**To:** Council **Date:** October 25, 2018  
**From:** Andrea Hudson, Acting Director, Sustainable Planning and Community Development  
**Subject:** **Update Report - Development Permit with Variances Application No. 00003 for 944 Heywood Avenue**

**Subject:** **Update Report: Development Permit with Variances Application No. 00003 for 944 Heywood Avenue**

Proposed Small Lot Subdivision - 944 Heywood Avenue

Landscape Plan  
Scale - 1:100

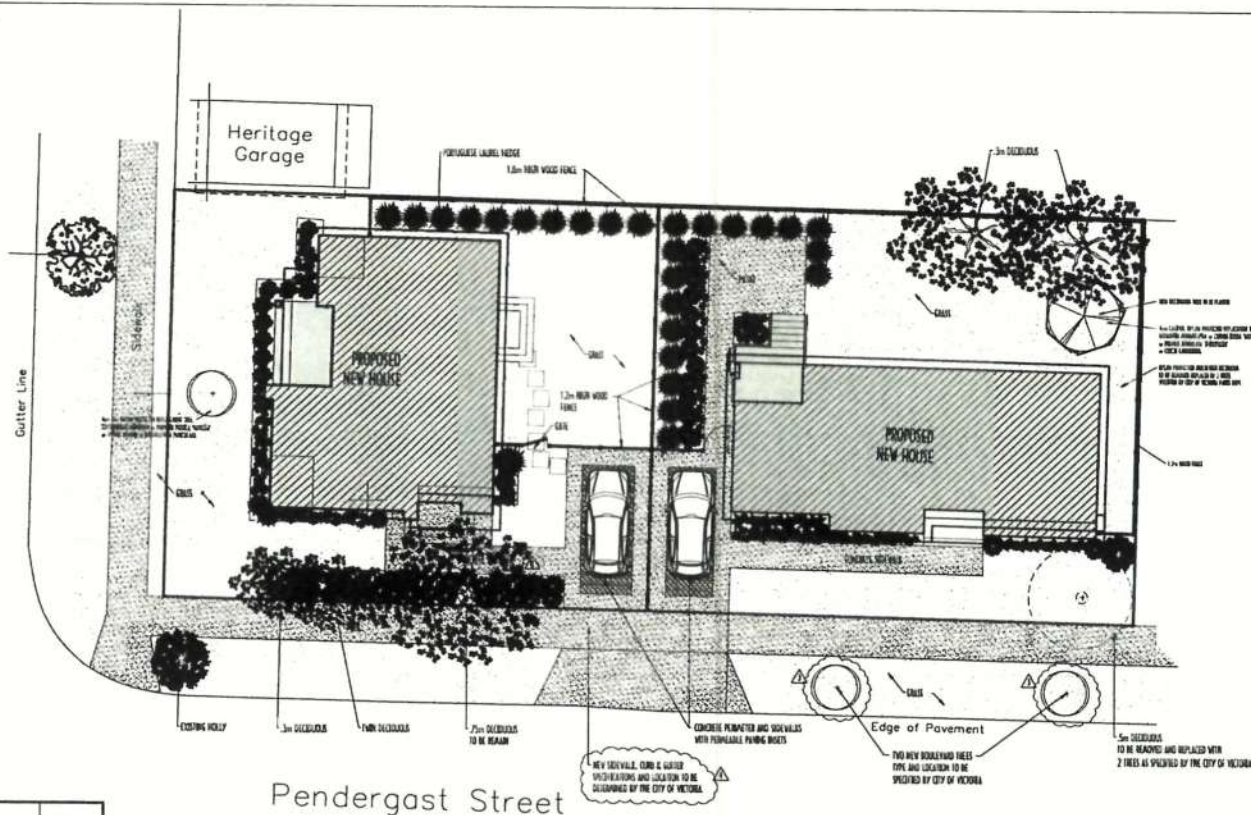
The purpose of this report is to inform Council that, in accordance with Council's motion of July 12, 2018 (staff report and minutes attached), the applicant has revised the plans to address errors and inconsistencies including corrections to notes on the plans, and inconsistent tree placement between the site plan, landscape plan, and street elevation. In addition, the applicant has made several other changes to the plans including reducing the height of the fence from 1.8m to 1.2m for portions of the fencing, moving the parking space for Lot B closer to the street, and changing the material of the path to the house on Lot A from permeable pavers to concrete.

The previous proposal showed the removal of two non-bylaw protected trees along the Pendergast Street frontage (a 0.75m deciduous tree on Lot A, and a 0.5m deciduous tree on Lot B). In response to the Council motion, the proposal has been revised to now retain the tree on Lot A, but still remove the tree on Lot B. The arborist has determined that impacts to the tree on Lot B will be too significant given the location of the proposed building footprint.
